REGISTRATION OF OCCUPATION CERTIFICATE WITH COUNCIL

Full Property Address: 44 Hillcrest Ave Newport
Proposed works: 2 storey dwelling, Swimming pool
Type of work: Building work.
DA no/CDC No. N1204/99 **Determination date:** 3/3/00

OCCUPATION CERTIFICATE

MEETING ENC 6TH FEB 2003

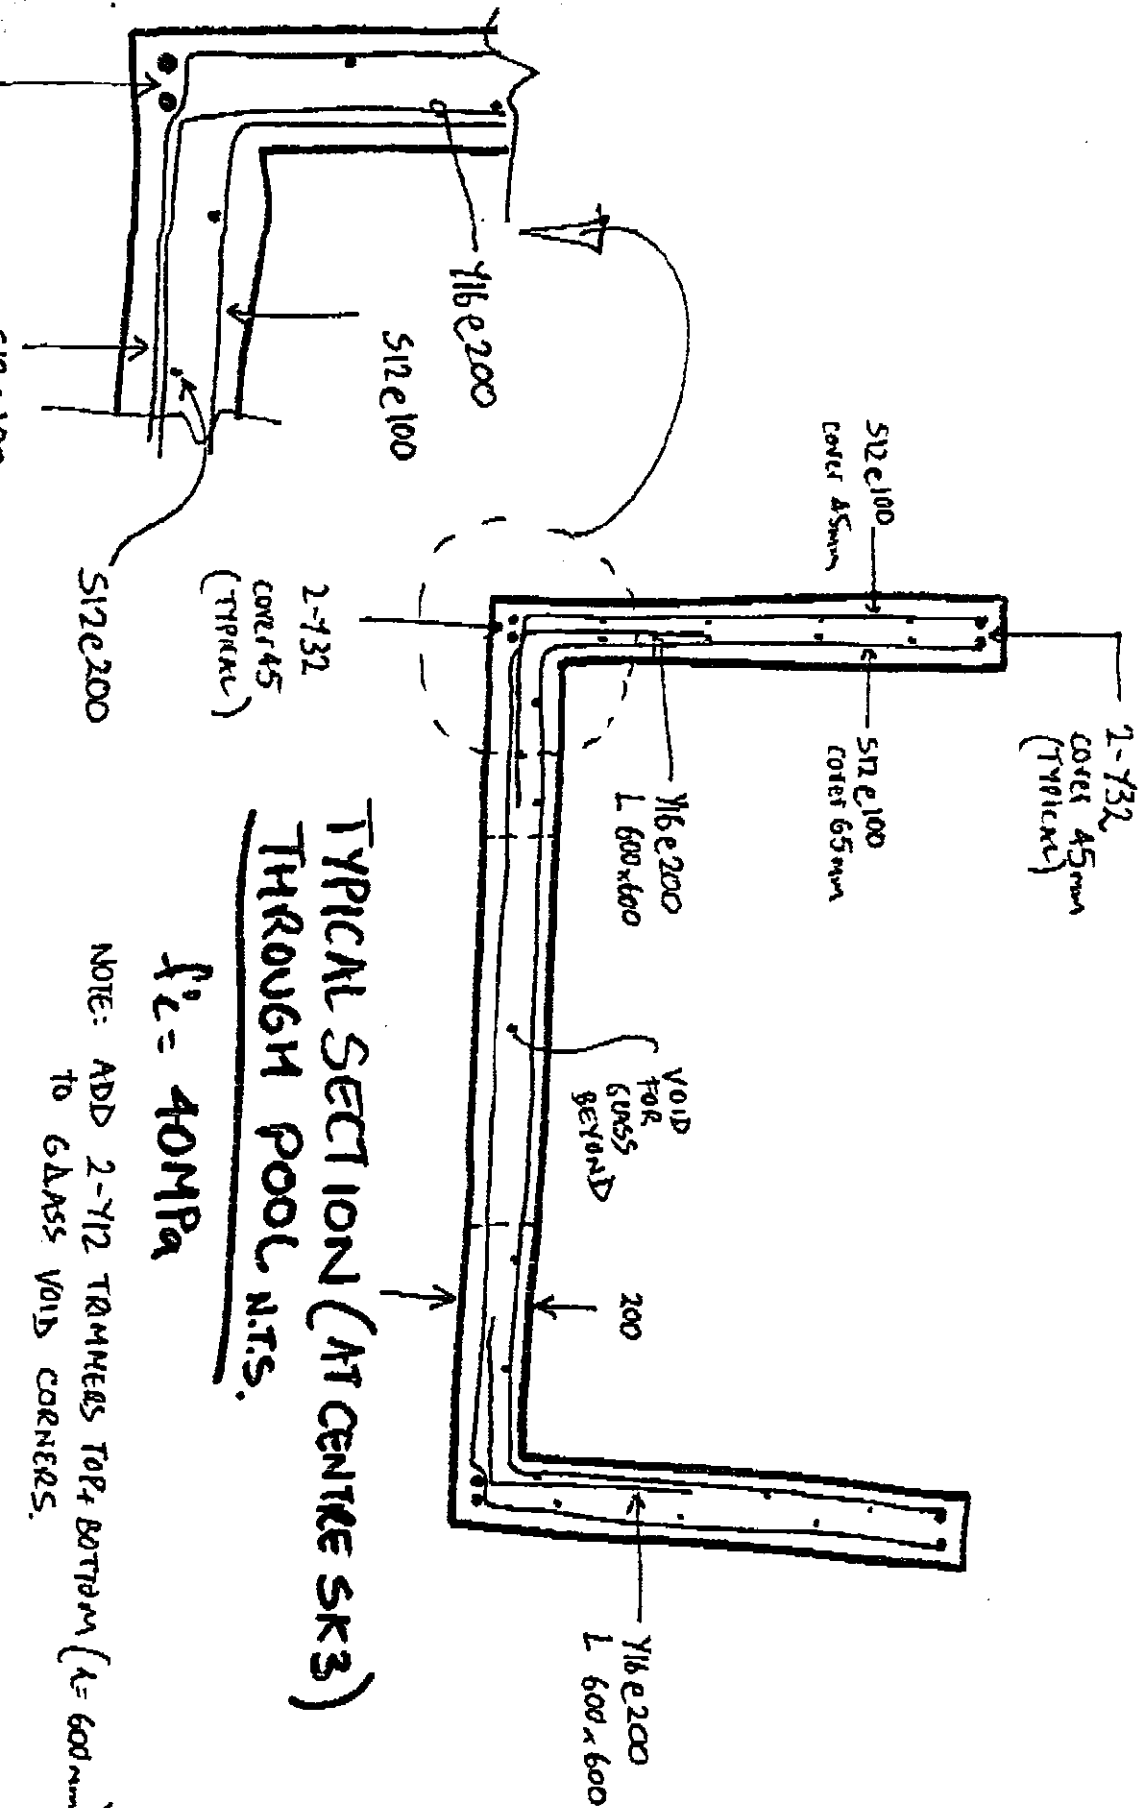
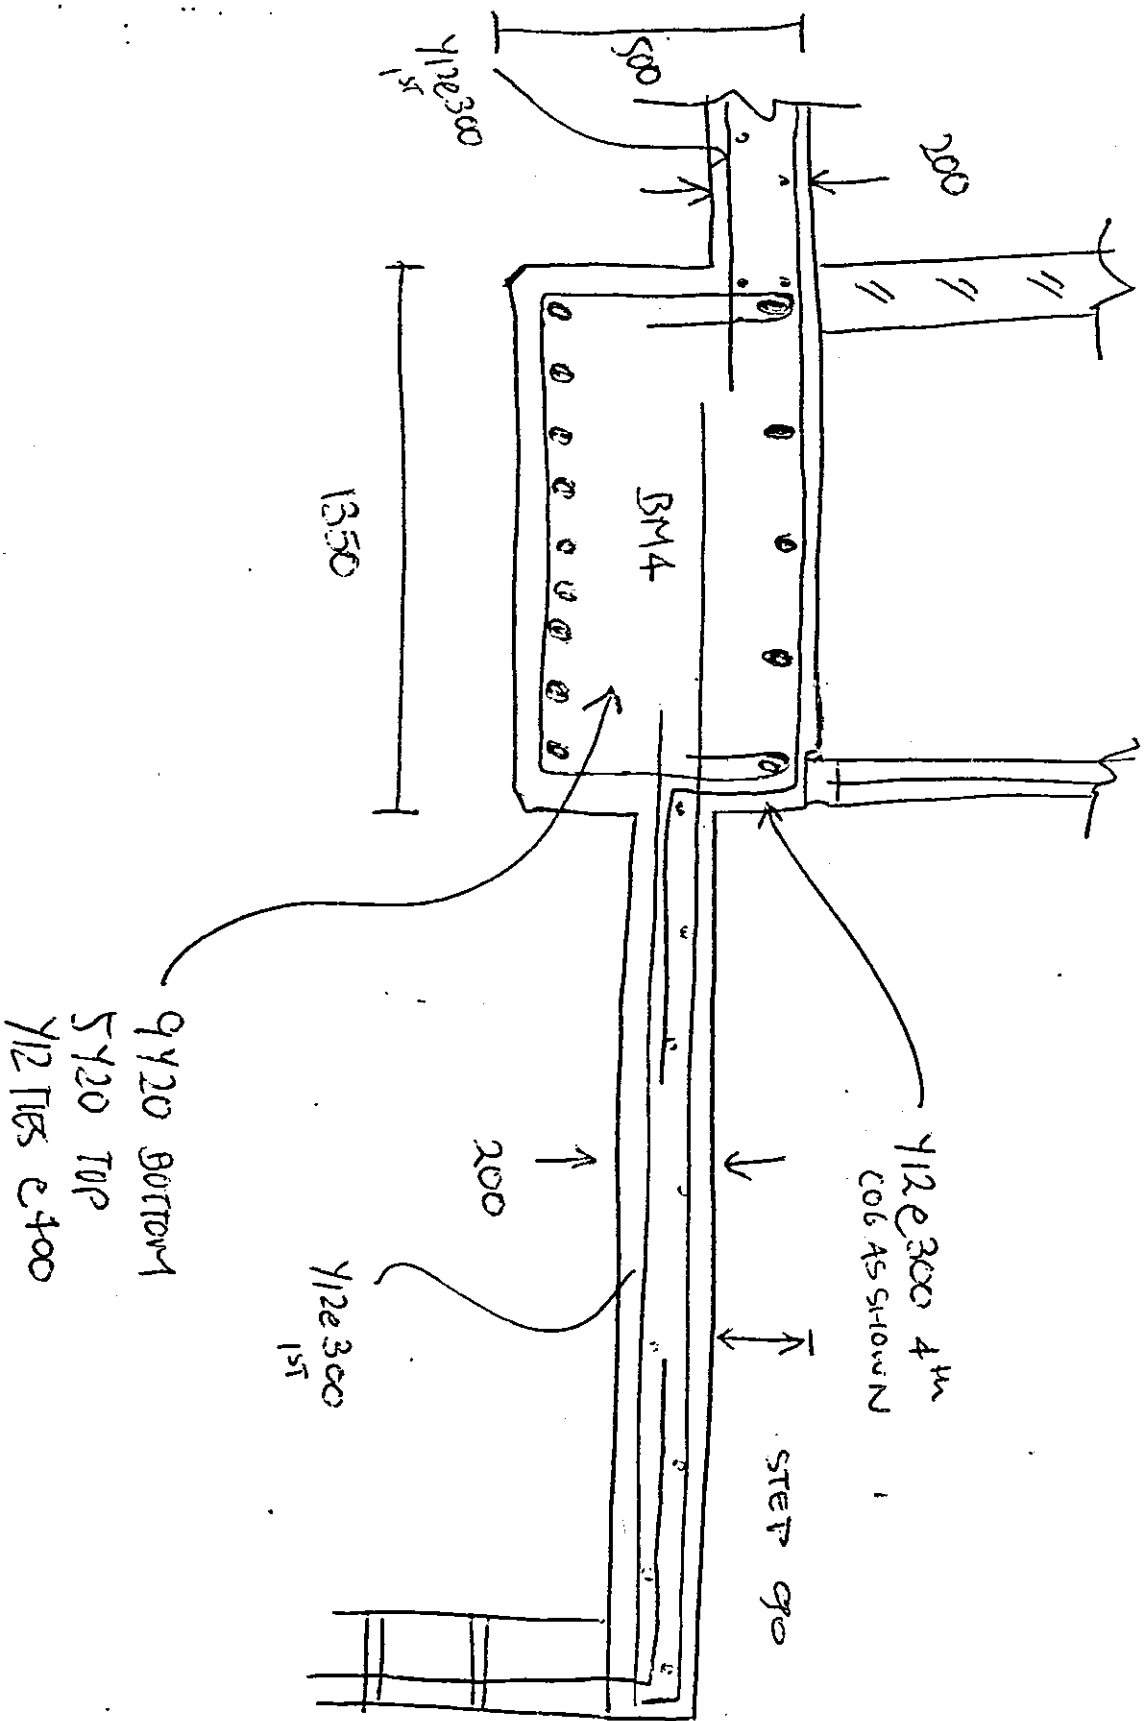
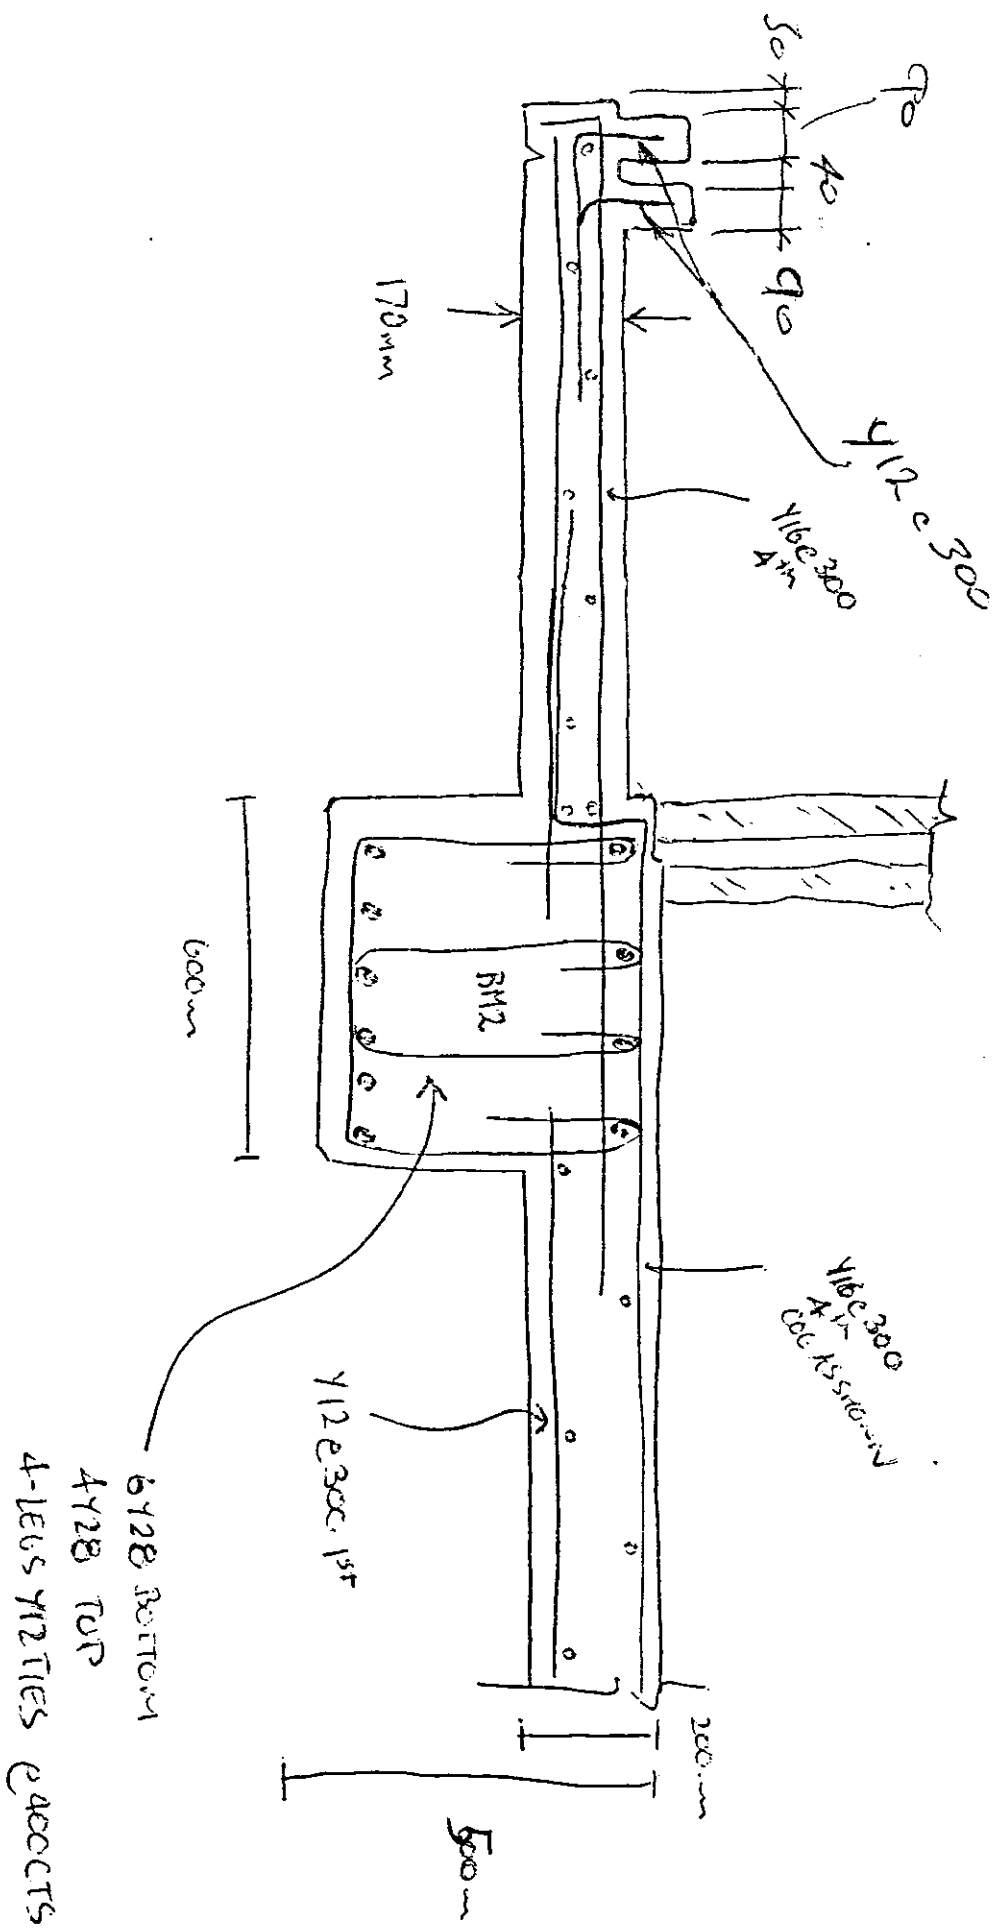
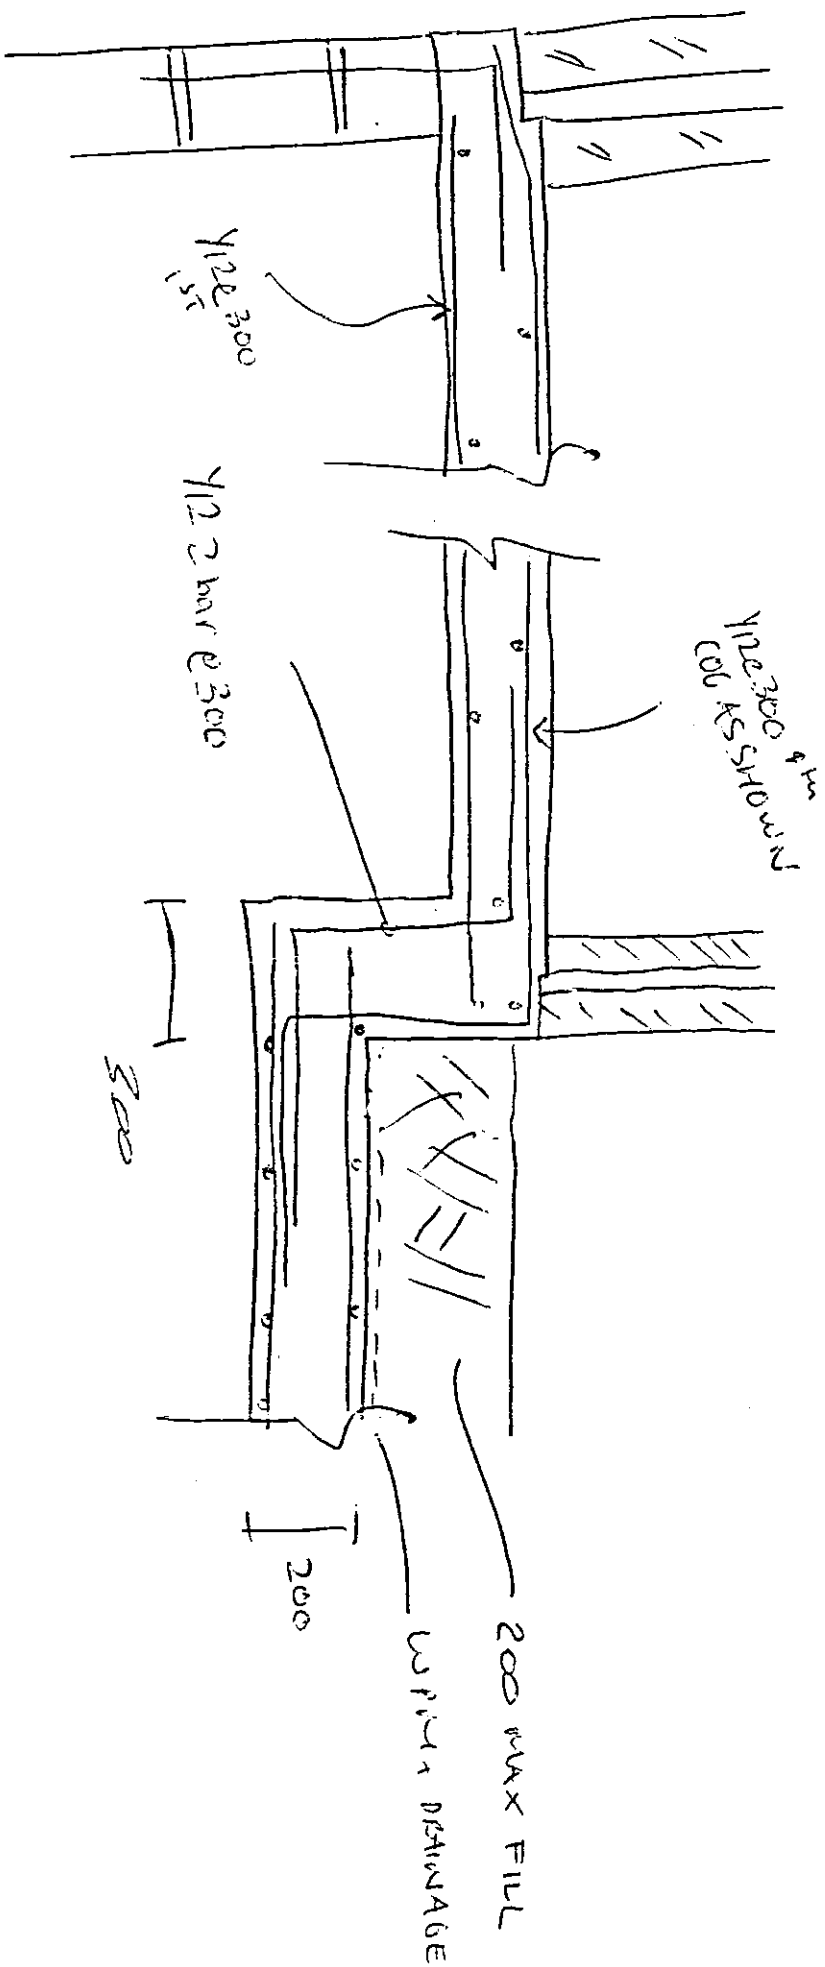
ORC WD4A

SECTION 1
WD4C

INCLUDE 3-Y12 TOP & BOT.
OVER COLUMNS

230 WIRE O'HANG FOR UPSTAIRS
BATHROOM NONE EXTRA REQD

3) SECTION 4
WD4C

18M 9 HAS 75 MM O'HANG
INCLUDE STEEL SUPPORT BY
EXTENDING BOTTOM Y12 REQD
ORC WD4C SECTION 4

10) SECTION 9
WD4C

NO STARTER BARS REQD.

11) SECTION 5
WD4C

SLIP JOINT REQD YES
EXPANSION JOINT REQD YES.

12)

2-Y32 BARS TOP & BOTTOM
END AT POOL ENDS.

13)

EXTRA OUTSIDE POOL REQD
S12 AT 200 CRS
